General Bid Bulletin No. 5
23 June 2022

OCB No. 22-003-5

Design and Build Contract for the Davao High Priority Bus System (HPBS)
Project - Contract No. 04 Sasa Depot and Sto. Nino Depot

**Davao High Priority Bus System (HPBS)
Contract Package (CP) 04 - Civil Works
Responses to Requests for Clarification (RFC) Batch 3**

STO NINO E-BUS DEPOT LAYOUT

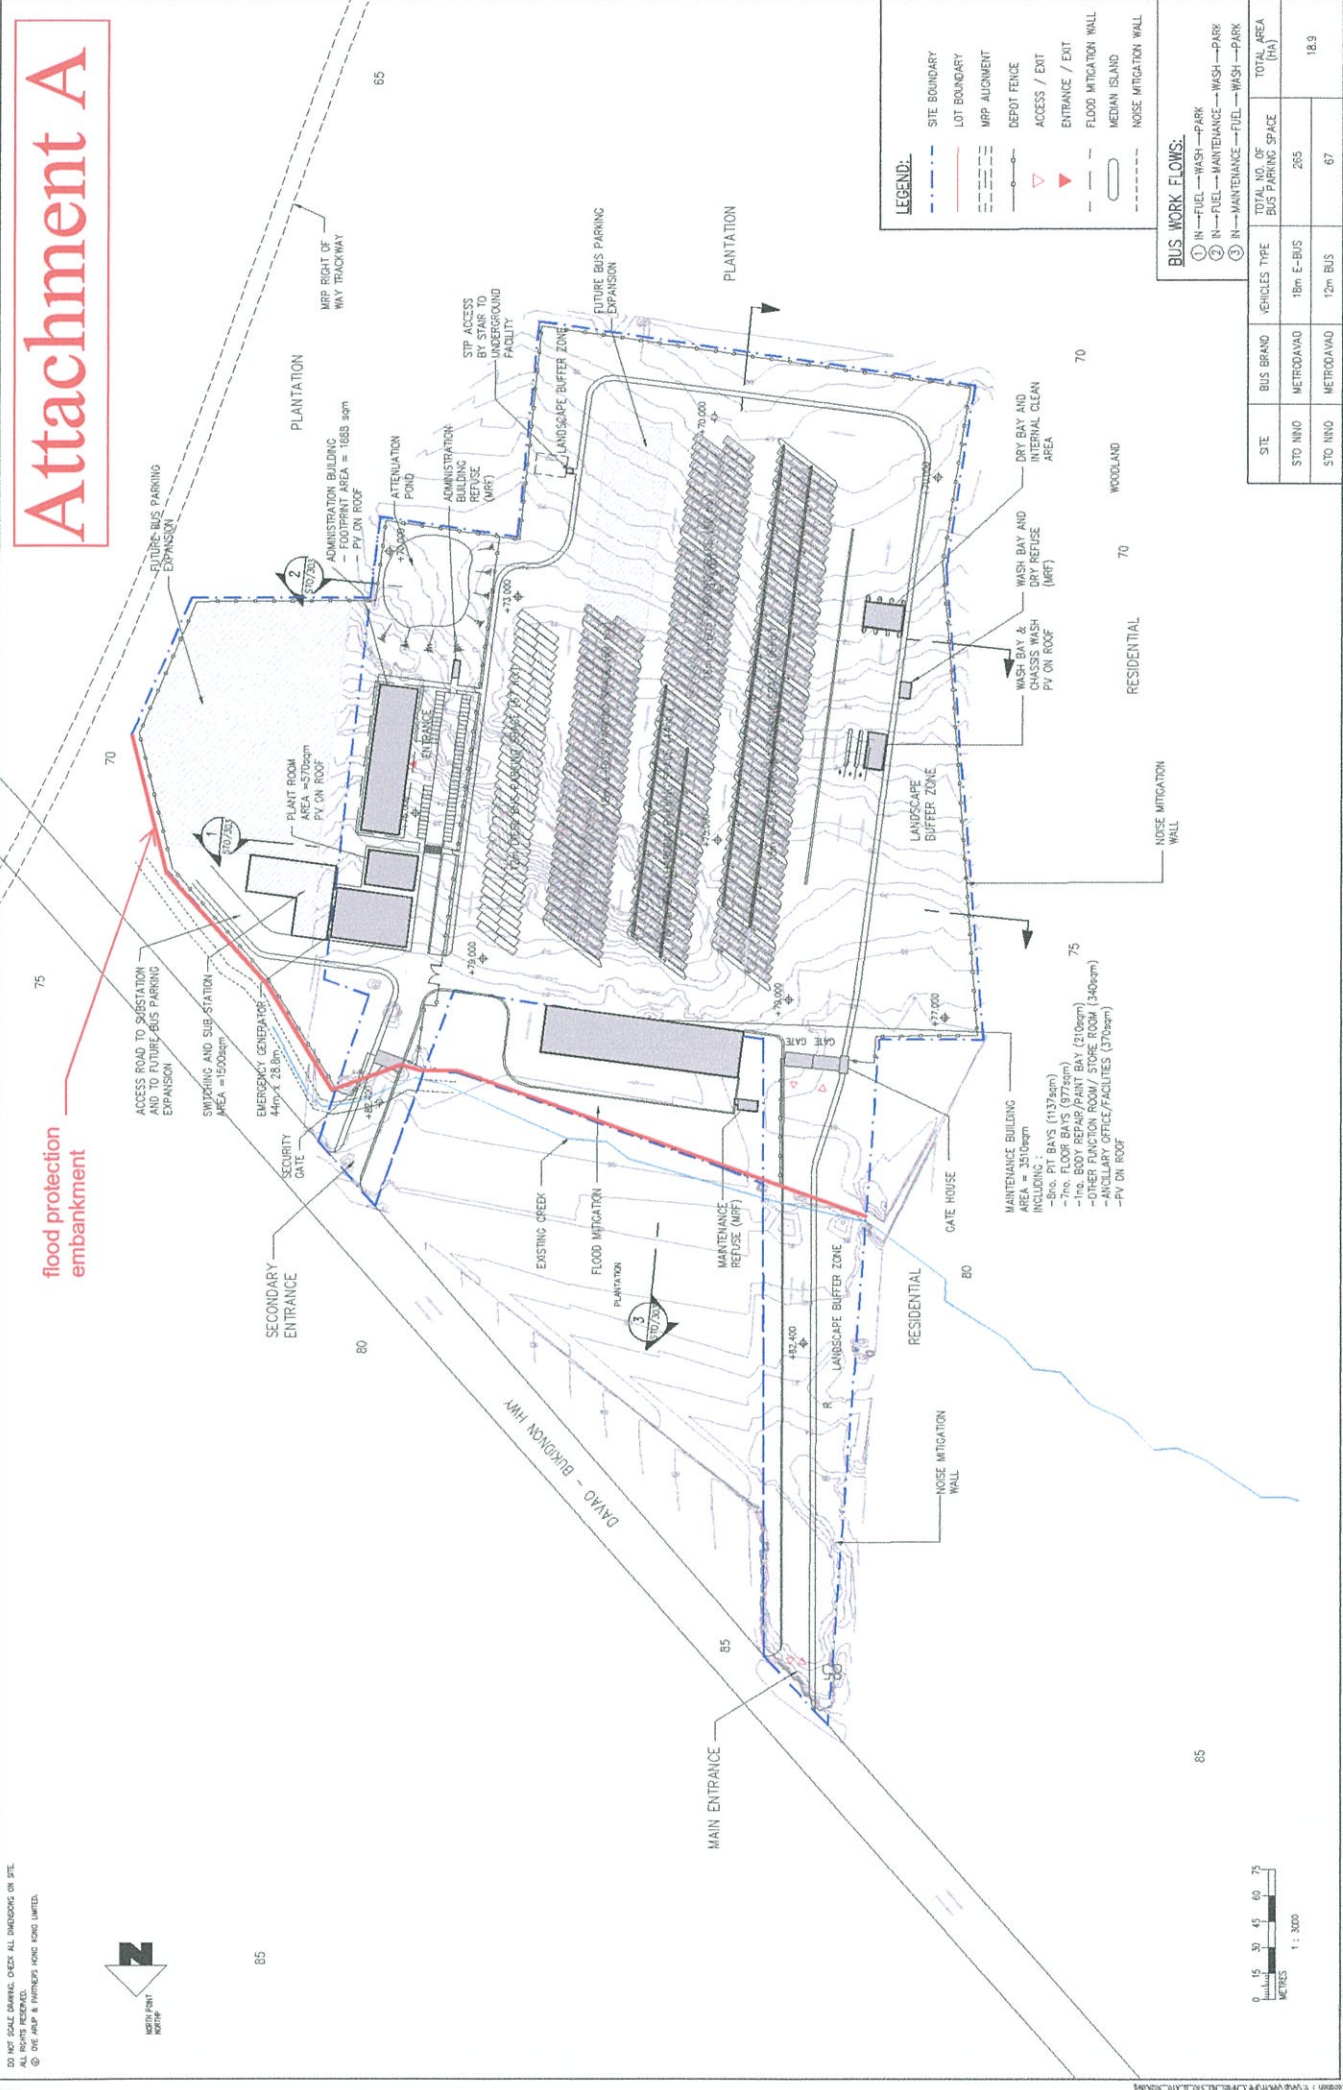
Item No.	Volume and Section No.	Page No.	Clause Number and Title	Reference Text (if necessary)	Clarification Request	Final Response
6	Vol. 2 Reference Drawings: Architect	Drawing No: IPIF3 /HPB S/RD /STO /D/A 10/3 02	Sto. Nino E-Bus Layout		<p>May we clarify if the flood mitigation structure to be designed and built for the creek is part of the scope of the project? If yes a. May we request for a hydrologic survey of the creek. b. The boundary or limitation up to which portion of the creek we have to build a flood mitigation structure c. History of flooding and water elevation when it occurs relative the creek bed.</p>	<p>The Contractor is required to design and construct the Works without affecting the existing creek and the existing embankment and will be responsible for the reinstatement should the construction works affect the existing creek and embankment. The Contractor is required to assess the project risk including but not limited to the flooding risk and should implement appropriate flood mitigation measures such as additional flood protection measures and drainage at the site perimeter as well as implement stormwater management design for the project sites as stated in the bidding document, especially Section 6, Part 1C, Design Specification, Section 7, Drainage and Stormwater Management Design.</p> <p>a. Feasibility Study on Flood Control and Drainage in Davao City report is provided under Site Data of Contract 04 for bidder's reference. This information shall not form a part of the Contract Document. It has been provided to the Bidder for information purposes only.</p>

17	Volume 2, Section 6 Reference Drawings - Architect	IPIF3_HPBS_RD_STO_D_A10_302A -Layout (1)	Sto. Nino E - Bus Depot Layout				Regarding the Flood mitigation structure to be built on the creek for Sto. Nino Depot, we noticed that the other side of the creek is outside of the Project Boundary. May we confirm that we only need to construct the flood mitigation on the side of the creek adjacent to the depot's boundaries.	The Contractor is not required to design and build the adjacent retaining wall at the other side of the creek. The Contractor is required to design and construct the Works without affecting the existing creek and the existing embankment, within the right-of-way. If the creek and the embankment is affected by the contractor's activities, the contractor is required to repair or rehabilitate the affected area of the creek to the satisfaction of the relevant authorities.
19	Volume 1 Part I SEC 1 ITB	ITB - 11 - 12	Bid Prices and Discounts	14.2 The Bidder shall fill in rates and prices for all items of the Works described in			Since we have the option to include items or introduce work items in the BOQ. May we inquire if you would allow us to add work items for	Bidder's attention is drawn to the Bid Data Sheet ITB 14.2. The Pricing Document included in the Bid Documents is intended to show a proforma

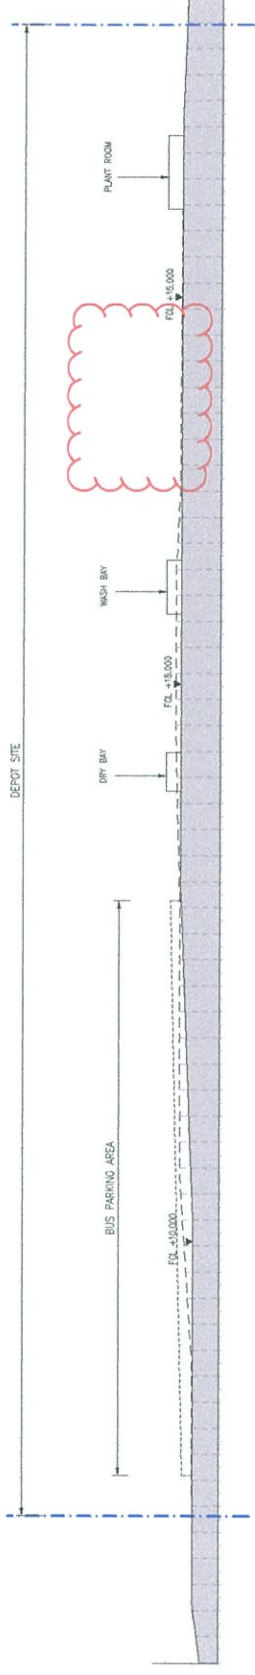
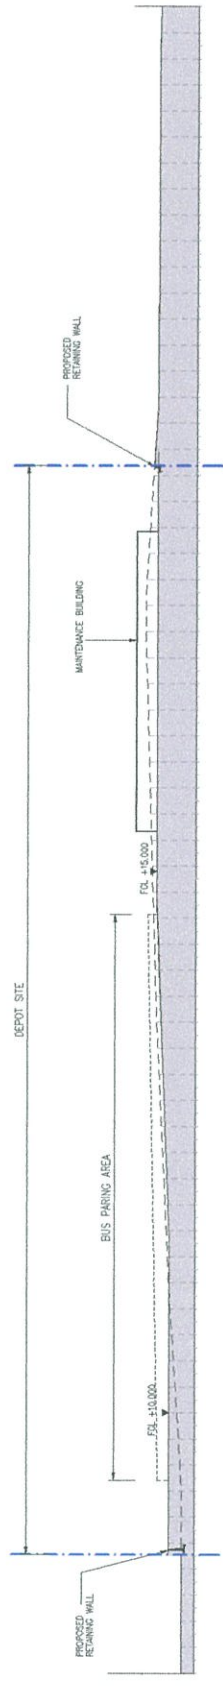
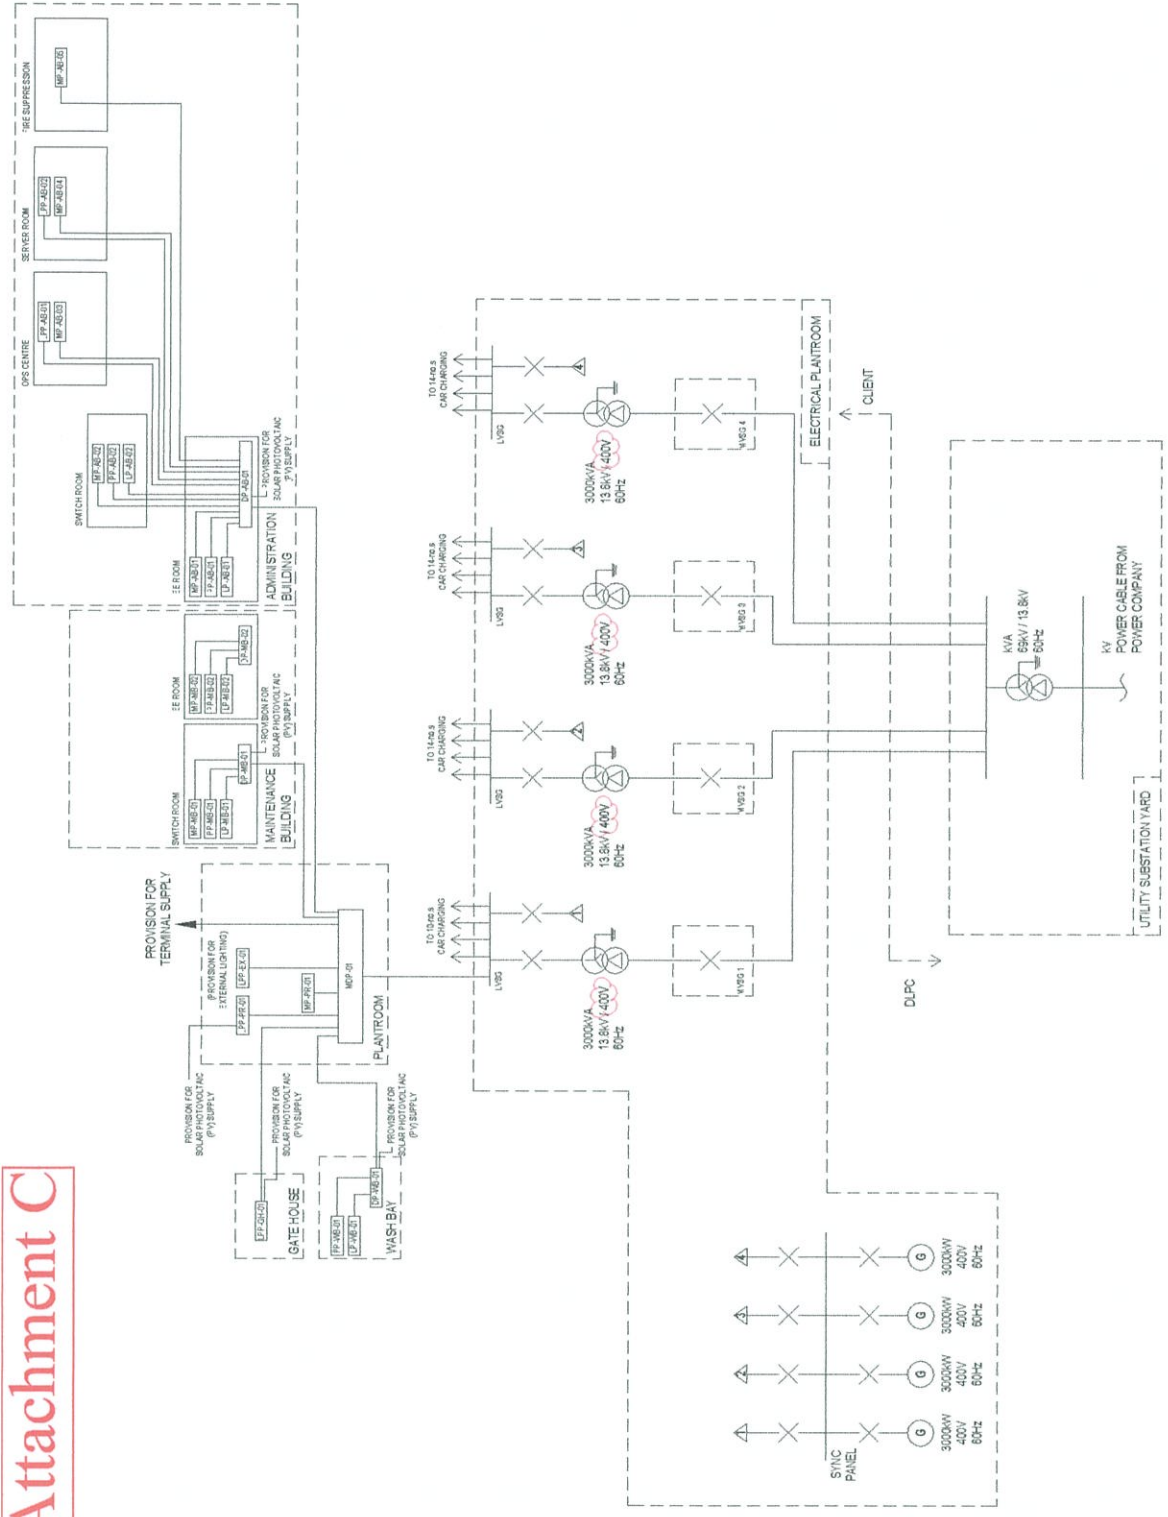
In the section drawings (section 4), there is a fuel area for the Sasa Depot however in the Plan view, there's no fuel area indicated in between Plant Room and Wash Bay. May we know which would prevail? We observed that there will only be E-Bus in Sasa Depot, may we know the purpose of the Fuel Area?
